SDP-9037-H5

Application	General Data	
Project Name: Summit Creek, Lot 18 (Stover Deck) Location: On the west side of Wooden Bridge Road, approximately 580 feet south of its intersection with Summit Creek Drive. Applicant/Address: Bertha Stover 10001 Wooden Bridge Lane Clinton, MD 20735	Planning Board Hearing Date:	06/02/16
	Staff Report Date:	05/17/16
	Date Accepted:	11/18/14
	Planning Board Action Limit:	06/06/16
	Plan Acreage:	0.17
	Zone:	R-S
	Dwelling Units:	1
	Gross Floor Area: (sq. ft.)	N/A
	Planning Area:	81A
	Council District:	09
	Election District	09
	Municipality:	N/A
	200-Scale Base Map:	213SE06

STAFF REPORT

SUBJECT: Homeowner's Minor Amendment to a Specific Design Plan SDP-9037-H5
Summit Creek, Lot 18 (Stover Deck)

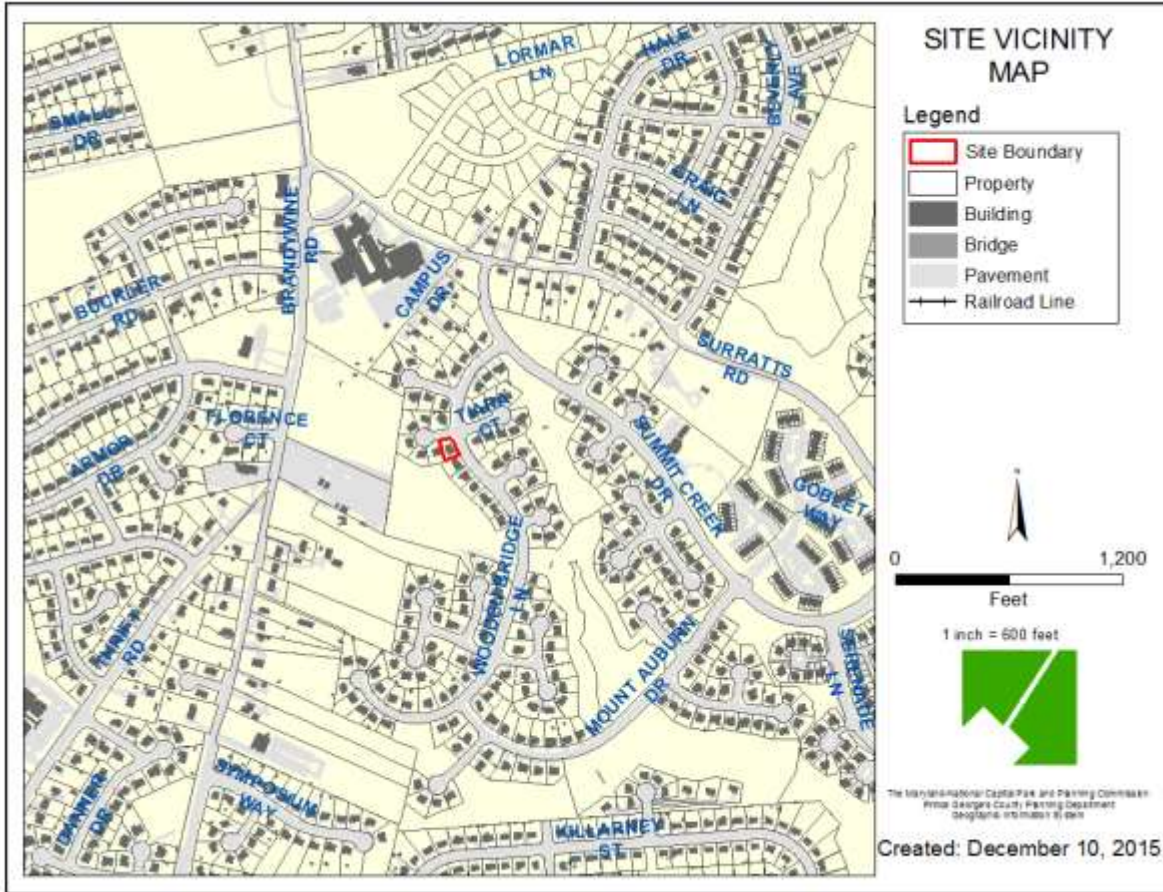
1. Prior to certificate approval of the specific design plan, the applicant and the applicant's heirs, successors, and/or assignees shall reference the following on the site plan:
 - a. Provide the dimension of the existing driveway on the site plan.
 - b. Label the material of the deck on the site plan.
